## **NON-FINAL OFFICE ACTION**

**10. Claims 1, 2, 3, 5, 6, 7, 8, 9, and 13 are rejected under 35 U.S.C. 102(b) as being anticipated by DE 3728901.**

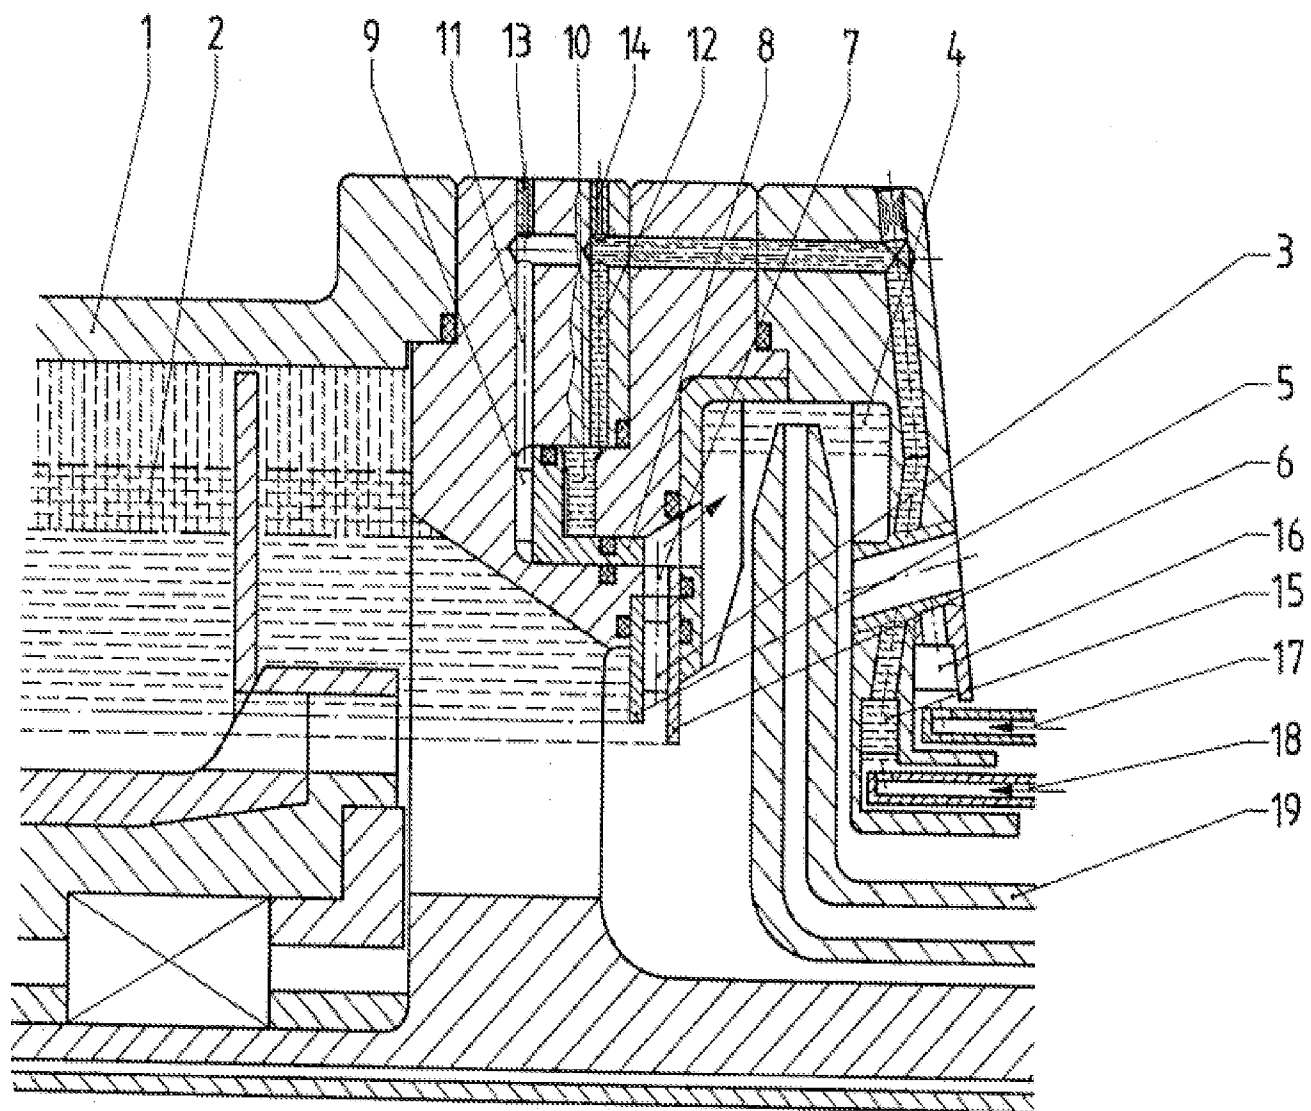
DE 3728901 discloses the recited screw type centrifuge with a centripetal pump 19 and adjustable throttling device 8 in front of the pump as seen in the Figure and as described in the abstract. The throttling device 8 is capable of being adjusted and is rotatable with the drum during an operation when the drum 1 is rotating and the throttling device 8 is capable of being adjusted and is stationary during an operation when the drum 1 is not rotating. The throttling device 8 has a disk portion (proximate 9). The throttling device 8 is axially movable per the abstract.

FIG. 1

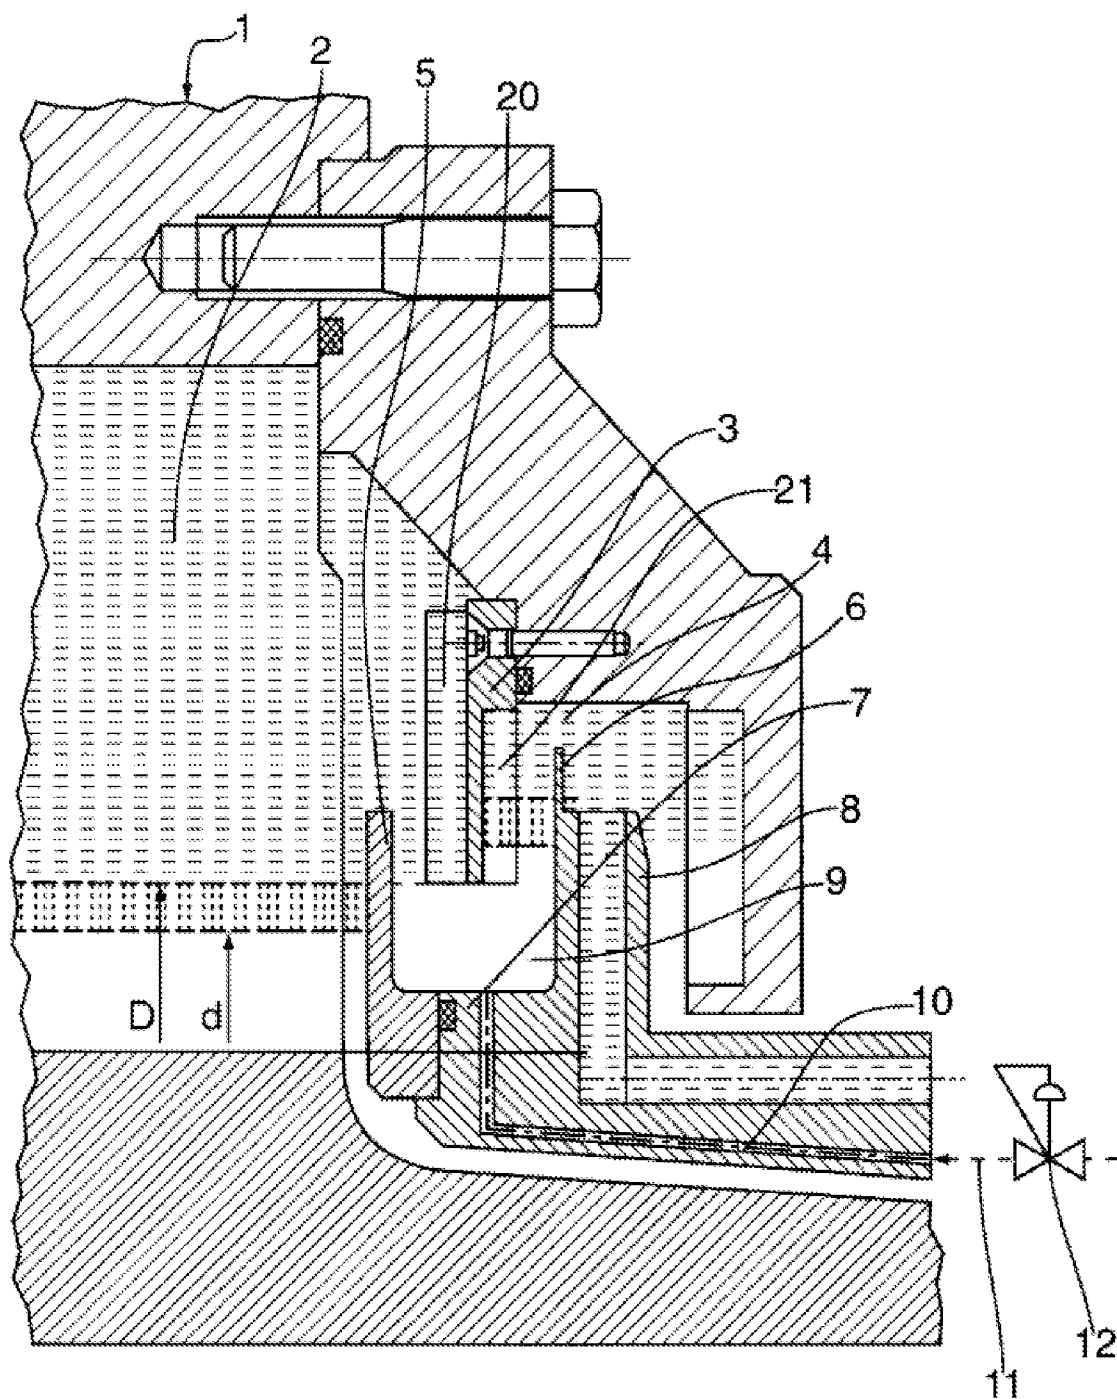
**11. Claims 1, 2, 3, and 5 are rejected under 35 U.S.C. 102(b) as being anticipated by Ostkamp (US 5,885,202).**

The patent to Ostkamp '202 discloses the recited screw type centrifuge with a centripetal pump 8 and adjustable throttling device 9-12 in front of the pump as seen in Figure . The throttling device 9-12 is capable of being adjusted (col. 2. line 60 – col. 3, line 8) and is stationary during an operation when the drum 1 is not rotating.

Fig. 1

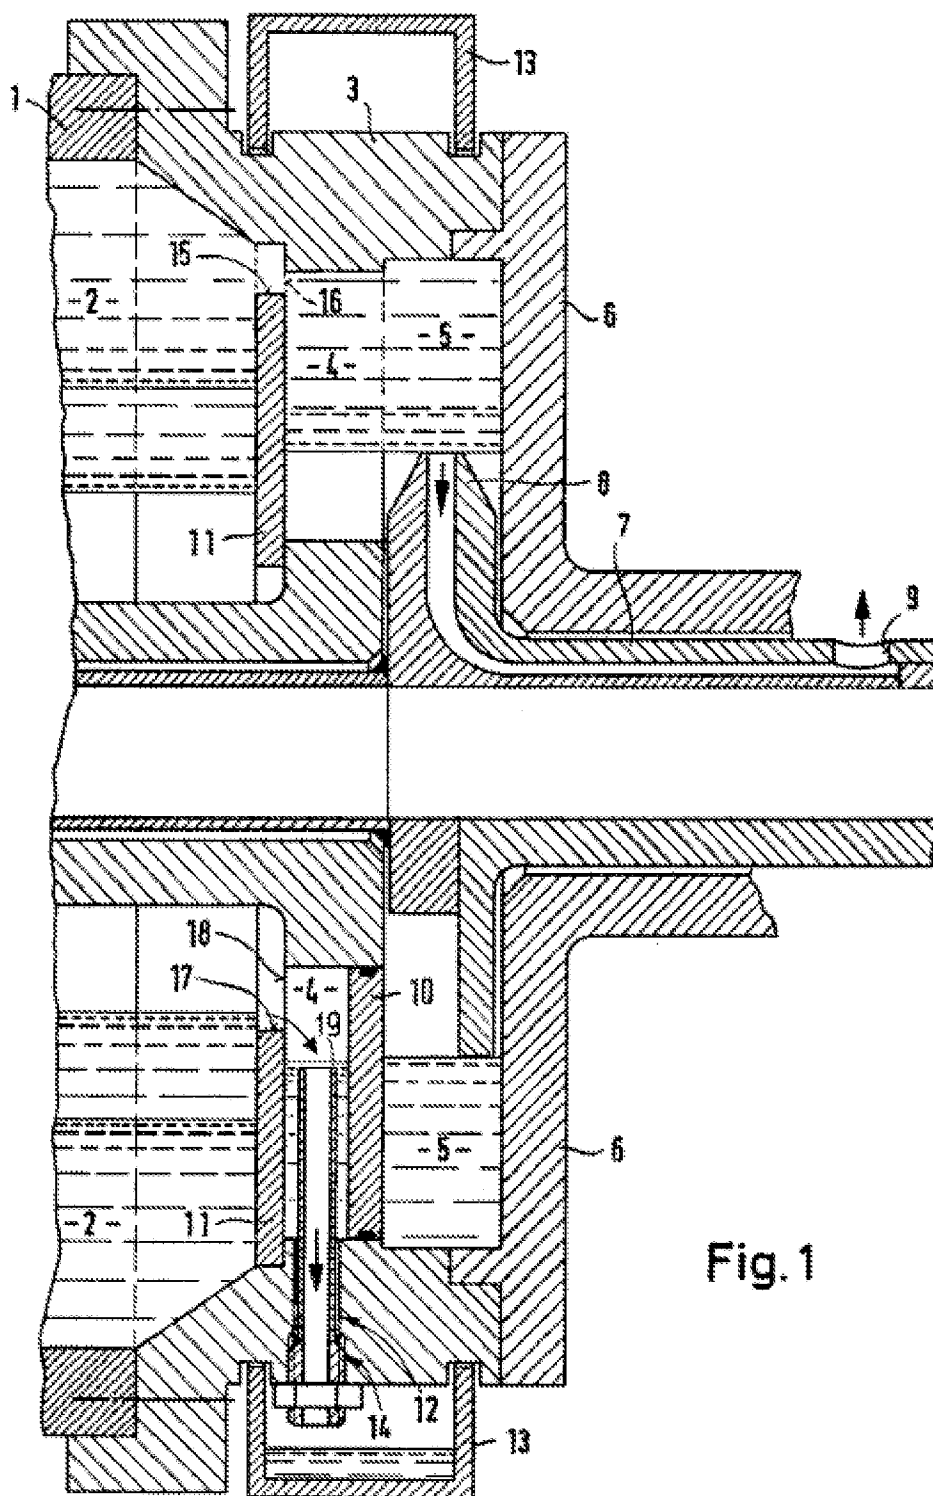
**12. Claims 1, 2, 3, 5, 6, 7, 8, 10, and 13 are rejected under 35 U.S.C. 102(b) as being anticipated by Ecker (US 4,615,690).**

The patent to Ecker '690 discloses the recited screw type centrifuge with a centripetal pump 8 and adjustable throttling device 11 in front of the pump as seen in Figs. 1-3. The throttling device 11 is capable of being adjusted and is rotatable with the drum during an operation when the drum 1 is rotating and the throttling device 11 is capable of being adjusted and is stationary during an operation when the drum 1 is not rotating. The throttling device 11 is a movable disk. The throttling device 8 is swivellable (see col. 2, lines 2-45; col. 5, lines 36-68 and Fig. 2).

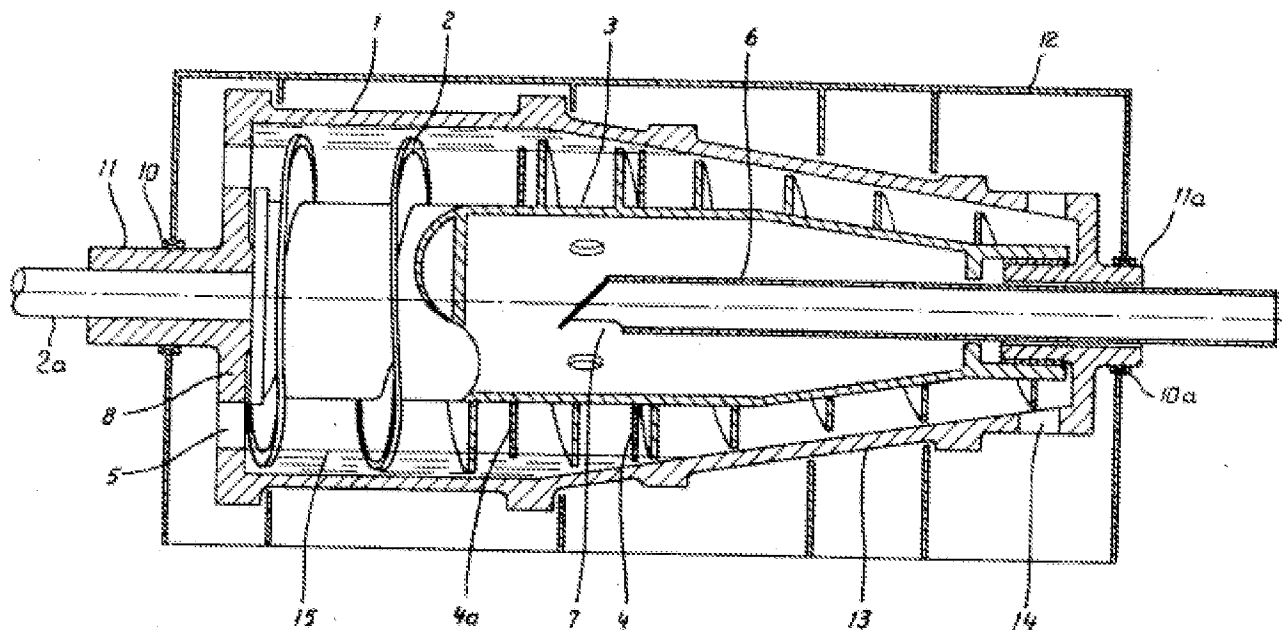
**15. Claim 4 is rejected under 35 U.S.C. 103(a) as being unpatentable over DE 3728901, Ostkamp (US 5,885,202), Ecker (US 4,615,690) in view of Eriksson et al. (US 3,447,742).**

DE 3728901, Ostkamp (US 5,885,202), Ecker (US 4,615,690) do not disclose the recited baffle plate. The patent to of Eriksson et al. '742 discloses a screw type centrifuge in the Figure having a baffle plate 4 or 4a on the screw 2, 3. It would have been obvious and mere common sense to one having ordinary skill in the art, at the time applicant's invention was made, to have provided DE 3728901, Ostkamp (US

5,885,202), or Ecker (US 4,615,690) with a baffle plate on the screw as taught by Eriksson et al. '742 for the purpose of preventing one of the separated phases (such as a fat or oil phase) from being discharged with the solids phase (col. 1, lines 34-55 and col. 2, lines 20-52).
